This letter is a request to amend Source Materials License no. SUC-1593, docket number 040-09083. Specifically, we request that the enclosed paragraphs and figures be added to the Programmatic RSP, "Radiation Safety Plan for IMCOM Ranges Affected by M101 Davy Crockett Spotting Round Depleted Uranium," dated December 31, 2015 (ML16004A369) (see item 11 in the license).

4.5 Training in Fort Hunter Liggett Range C8 Target Zone/Impact Area

4.6 Vehicle Passage through the Fort Jackson Range 62

Figure 4-1 IED Defeat Lane (shown by arrows) in Range C8 RCA at Fort Hunter Liggett

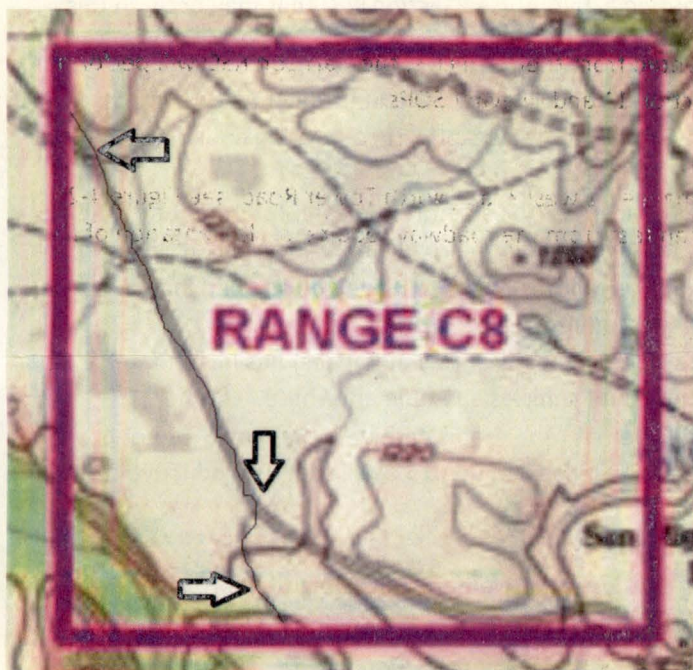
All personnel directly involved in Improvised Explosive Device (IED) Defeat Lane training events in the Fort Hunter Liggett Range C8 RCA (see Figure 4-1) are exempt from the radiation safety requirements of this RSP. This exemption does not apply to routine activities (see Section 4.3) that may occur in this RCA, such as target maintenance. This exemption is permissible because:

Vehicles are restricted to the IED Defeat Lane road within the Range C8 RCA (see Figure 4-1). Units will maneuver on foot only within 200 yards of the IED Defeat Lane road within the Range C8 RCA.

Figure 4-2 North Tower Road (shown by arrow) in Fort Jackson RCA.

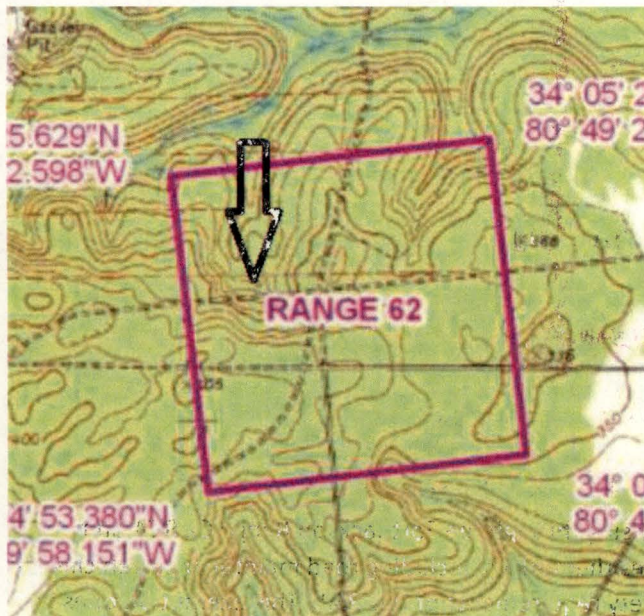
All personnel and equipment riding in vehicles passing through the Fort Jackson Range 62 RCA on the North Tower Road (see Figure 4-2) and the vehicles themselves (including road maintenance vehicles on the main road) are exempt from the radiation safety requirements of this RSP. This exemption does not apply to routine activities (see Section 4.3) that may occur at other times in the RCA. This exemption is permissible because:

Vehicles and personnel are restricted to the main east-west road (North Tower Road, see Figure 4-2) while in the RCA. Departures for more than ten feet from the roadway require implementation of all pertinent RSP requirements.
